L-2001-005  
10 CFR 50.90  
10 CFR 50.4

Re: St. Lucie Unit 1  
Docket No. 50-335  
Proposed License Amendment  
Performance of EDG 24-Hour Surveillance  
Requirement in Modes 1 and 2 and Conforming Amendments

Attachment 1 is a Safety Analysis in support of the proposed amendment. Attachment 2 is the Determination of No Significant Hazards Consideration. Attachment 3 is marked up copies of the proposed Technical Specification changes.

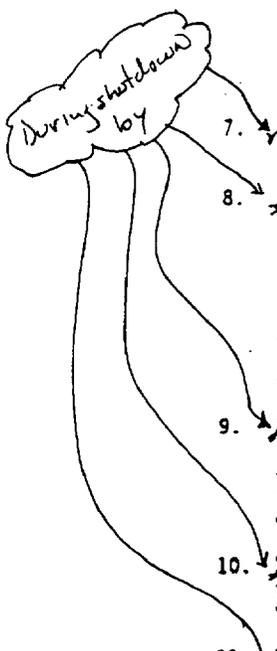
During shutdown by
